R.13-11-005

SOUTHERN CALIFORNIA EDISON COMPANY'S (U 338 E) COMMENTS ON ADMINISTRATIVE LAW JUDGE'S RULING INVITING COMMENTS ON DRAFT POTENTIAL AND GOALS STUDY

Dated: May 21, 2019

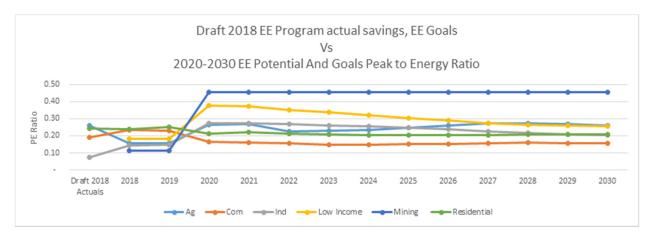
iv. SCE recommends reevaluating the measure level savings for the Mining and Low Income Sector.

SCE evaluated the Peak to Energy Ratios (MW/GWh) comparing 2018 Draft EE Program actual savings 2018/2019 EE Goals to the Draft 2019 EE Potential Study. The graphic

below shows that the Mining and Low Income Peak to Energy Ratios are out of alignment with past program performance. SCE recommends that Energy Division / Navigant reevaluate the measure level saving value inputs 10 to assure congruence with the EE Program ability to capture savings.
